MAINTENANCE MANUAL
for
GENERAL PURPOSE TRANSMITTER
MODEL GPT-10KRF

General Purpose Transmitter GPT-10KRF is similar to the standard GPT-10KR transmitter with the following modification: (1) Provision has been made for automatic switching to an external 1-mc standard upon failure of the internal 1-mc standard. (2) Power-input circuits have been modified to accept high-voltage or low-voltage input power.

Addendum #1 to
GPT-10K Maintenance Manual
(IN-316)

Figure 3-7A

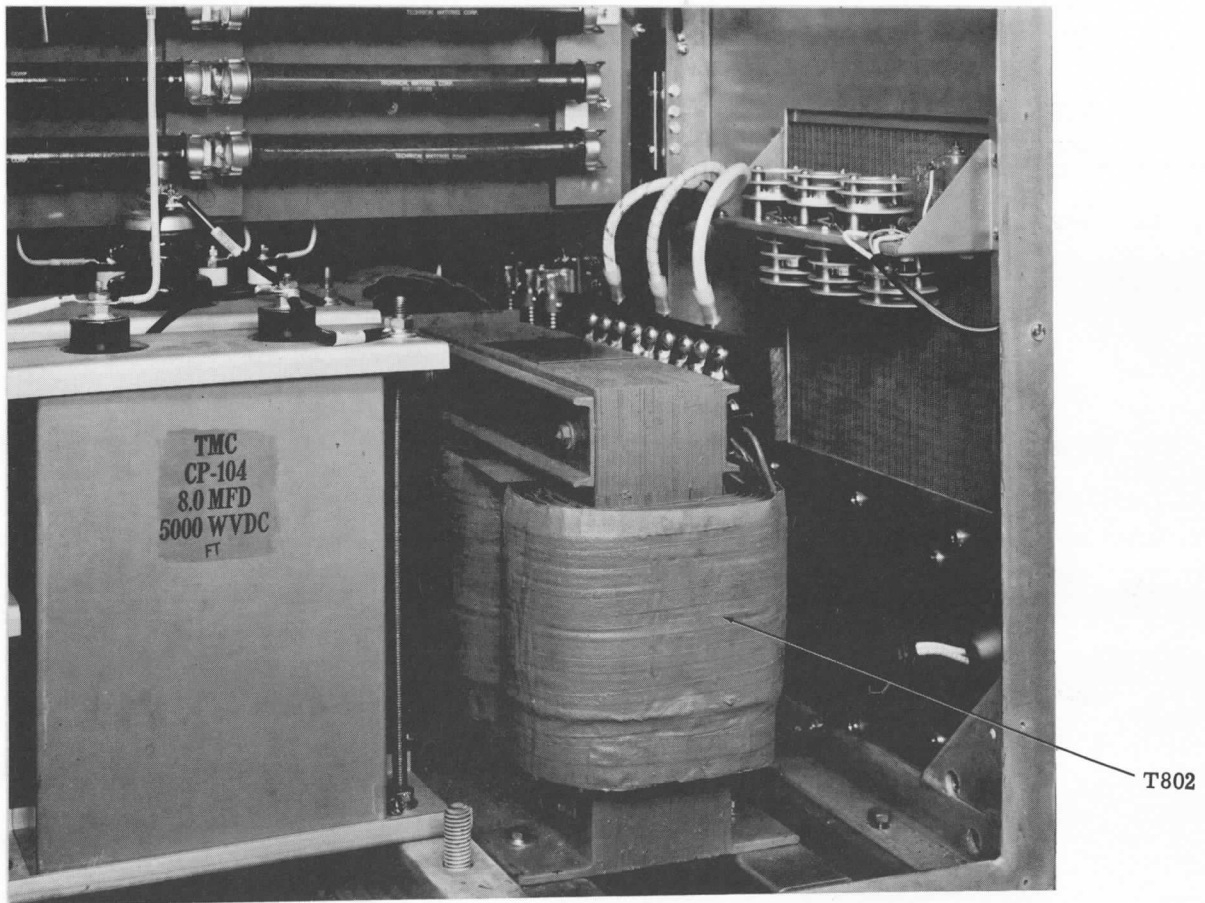
Figure 3-7 should be changed in accordance with information contained in figure 3-7A provided with this addendum.
